- 3. Caribou Crossing Subdivision; KPB File 2024-054  
Edge Survey & Design, LLC / Kenai Peninsula Borough  
Location: Heather Avenue & Maudi Drive  
Kalifornsky Area**

**ITEM #3 - PRELIMINARY PLAT  
CARIBOU CROSSING SUBDIVISION**

<b>KPB File No.</b>	2024-054
<b>Plat Committee Meeting:</b>	June 10, 2024
<b>Applicant / Owner:</b>	Kenia Peninsula Borough
<b>Surveyor:</b>	James Young / Edge Survey and Design Inc
<b>General Location:</b>	Northeast end of Kalifornsky area near high end of Kenai River bow. Kalifornsky APC

**Specific Request / Scope of Subdivision:** The proposed plat will subdivide a 19.998 acre parcel into five lots ranging in size from 2.937 acres to 4.448 acres and a right-of-way dedication.

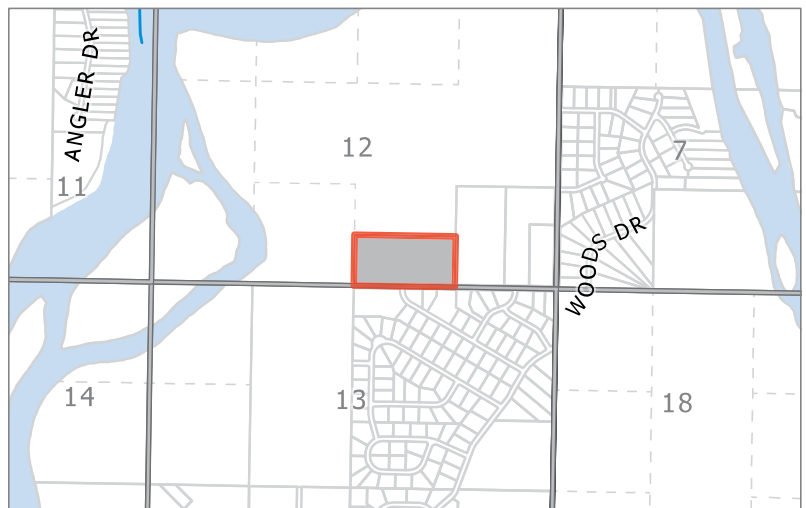
Add label to Kenai Spur Highway in the vicinity map.  
Modify the KPB File No to 2024-054.  
Lot 4A to the southeast needs the Block 2 removed

**Staff recommendation:**  
Add label to Kenai Spur Highway.
- H. Approximate locations of low wet areas, areas subject to inundation, areas subject to flooding or storm water overflow, and the line of ordinary high water. This information may be provided on an additional sheet if showing these areas causes the preliminary plat to appear cluttered and/or difficult to read;

## CARIBOU CROSSING SUBDIVISION

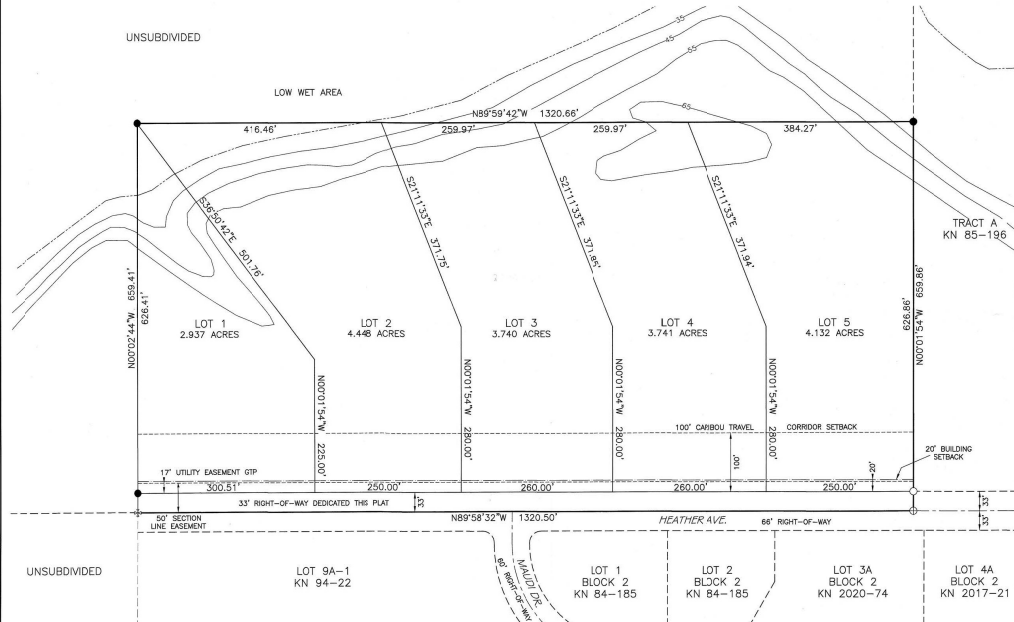
The subdivision is affected by a 50 foot section line easement on the south line of the subdivision as noted. It is recommended to move the note to a location and flag to make it easier to identify.

There are steep areas shown on the plat by the contours but they are not flagged as such. The contours, when analyzed, show a steepness of 37% in proposed Lot 2 and 30 % in the corner of proposed Lot 5. **Staff recommends:** for the final submittal, the contours be removed and slopes of 20% grade or more be identified.

There is a drainage ravine shown on Lot 1 indicated by the contours. **Staff recommends:** the surveyor identify the drainage area on the final in a form easily understood to be an unbuildable drain area.

KWF Wetlands Assessment shows lakebed and drainageway appear across the proposed parcels of the plat. These areas should be noted and identified on the drawing of the final plat. the appropriate plat note is present on the drawing at #3 and should remain for the final plat submittal.

The subdivision is located in a FEMA identified flood zone of Zone C and D. Per 20.30.280.D., the Flood Hazard Notice needs to be added to the plat as a plat note or a general notation. The note should include the FIRM Panel number and Zone the plat is within. **Staff recommends:** the Plat Committee concur plat note #3 to remain and the surveyor to add the Flood Hazard Notice to the plat.

The surveyor has indicated a 100' Caribou Travel Corridor Setback on the plat. **Staff recommends:** the surveyor either identify the source of the setback or if being dedicated by this plat, label it as "dedicated this plat".

- B. North point;  
**Staff recommendation:**  
Add a "N" to the arrow for north designation
- C. The location, width, and name of existing or platted streets and public ways, railroad rights-of-way, and other important features such as section lines or political subdivisions or municipal corporation boundaries abutting the subdivision;

**Staff recommendation:**  
Add 33' section line easement to the east on both sides of section line  
Add 33' section line to the south of property  
Add 50' section line easements to the west on both sides of the section line  
Move the 50' section line easement note to above into the subdivision for better notation.  
Label 33' right of way on the south part of Heather Ave and add total to the 66' right-of-way

**Staff recommendation:**  
KWF Wetlands Assessment lakebed and drainageway should be noted and identified on the plat.
- J. Block and lot numbering per KPB 20.60.140, approximate dimensions and total numbers of proposed lots;

**Staff recommendation:**  
Fix overstrikes on dimensions on interior with the corridor setback line.
- M. Approximate locations of slopes over 20 percent in grade and if contours are shown, the areas of the contours that exceed 20 percent grade shall be clearly labeled as such;

**Staff recommendation:**  
Steep areas need identified.

- A. The planning commission may require easements it determines necessary for the benefit of the public. Such easements include, but are not limited to, lateral support (slope) easements, drainage easements for ditching or protection of a drainage, and utility easements. Required easements do not need to be for road purposes.  
Label source of 100' Caribou Travel Corridor Setback or if dedicated this plat, label so.

Add Certificate of Acceptance for Heather Ave
